CREEKSIDE AT LORSON RANCH FILING NO. 1 PUD Development & Preliminary Plan

CREEKSIDE AT LORSON RANCH
FILING NO. 1
El Paso County, Colorado
PUD & PRELIMINARY PLAN

PCD FILE NO.: PUDSP-18-5

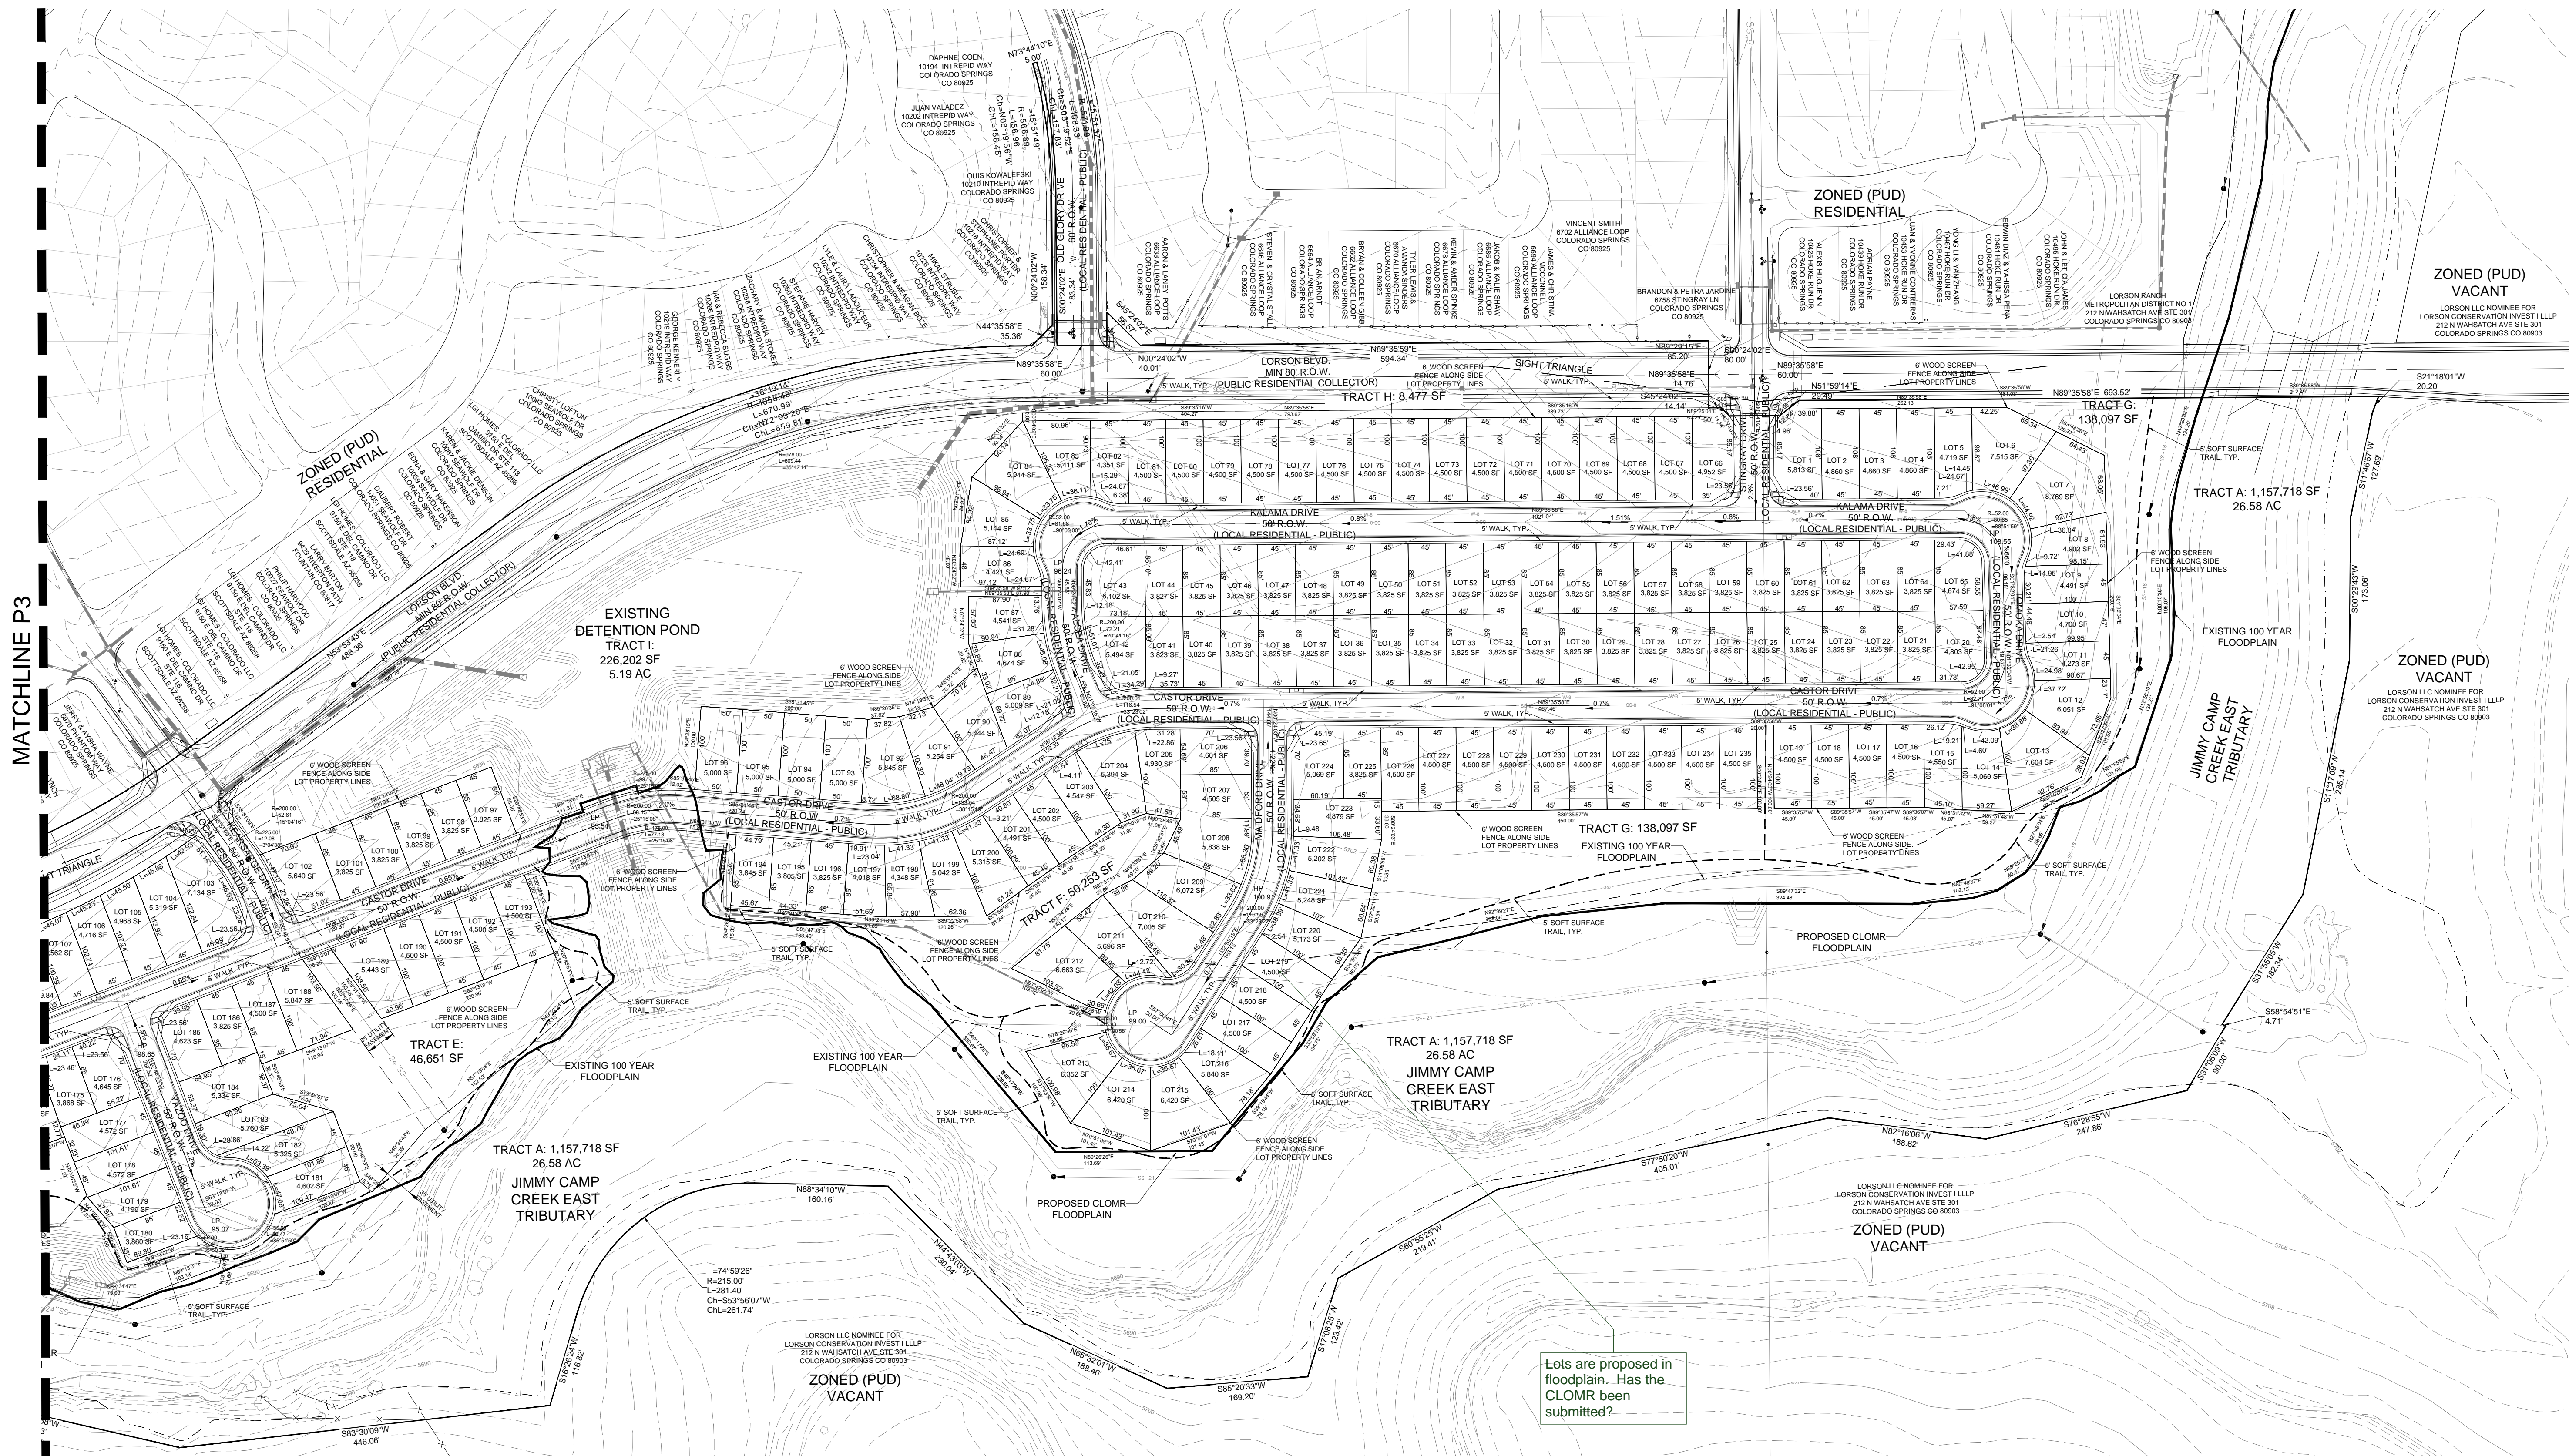
Can you please utilize dots or squares for the trail system? It is very hard to determine the difference between the trail, the floodplain, easements etc... All sheets

Matchline doesn't match next sheet

SITE PLAN

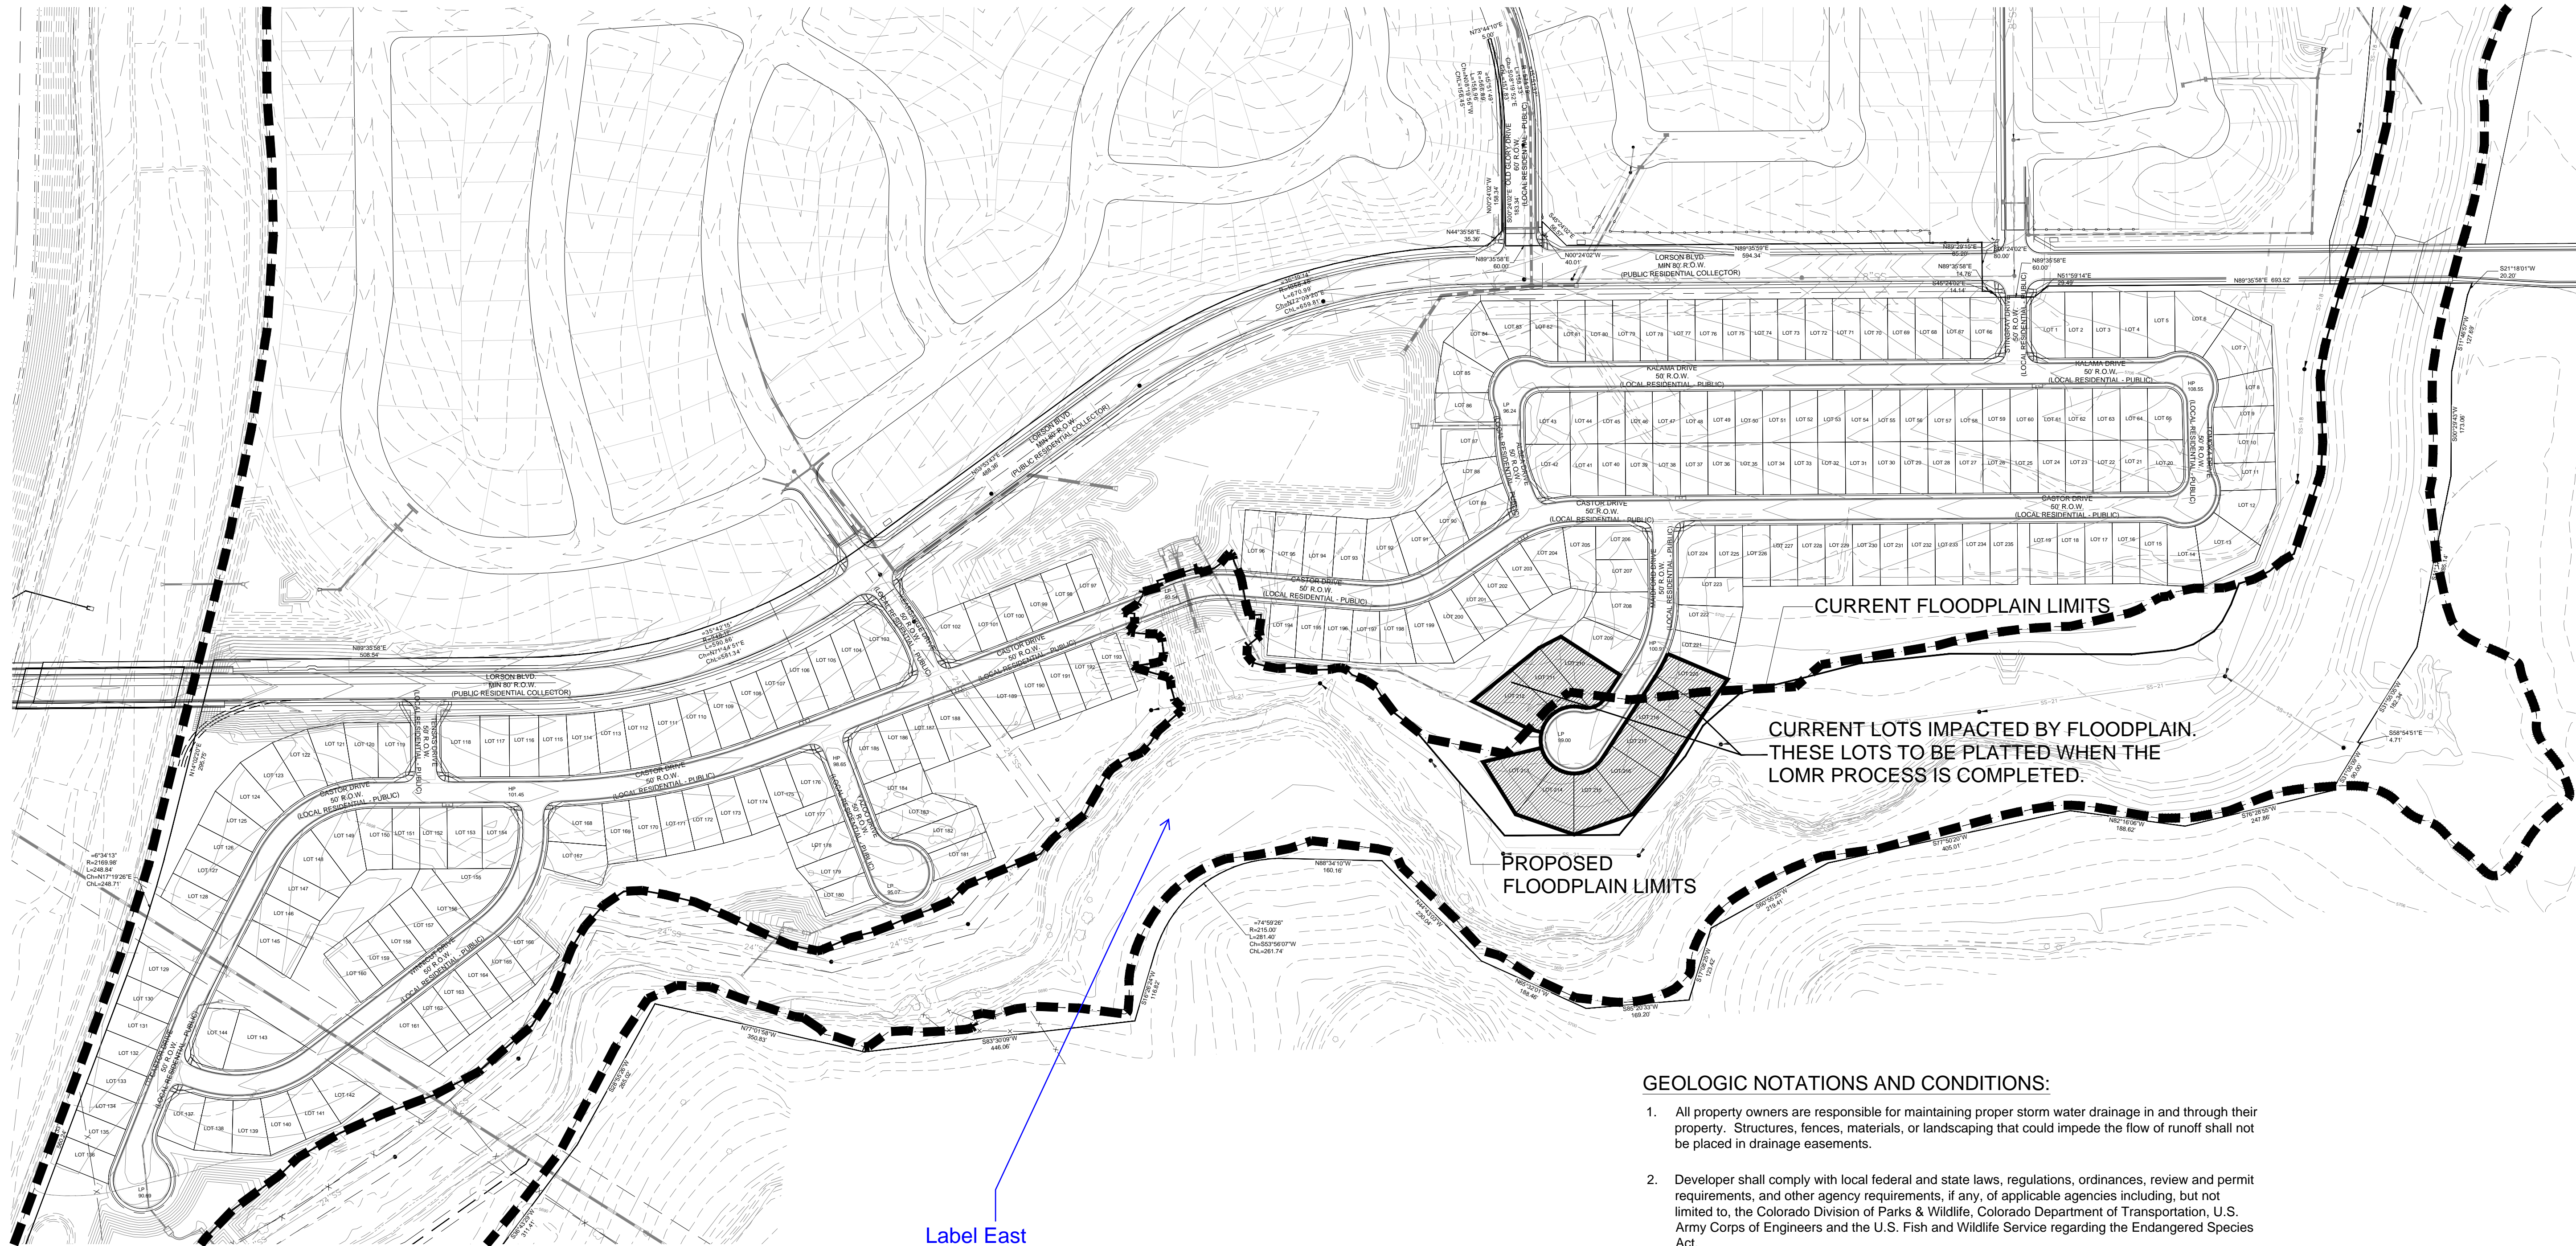
Lots are proposed in floodplain. Has the CLOMR been submitted?
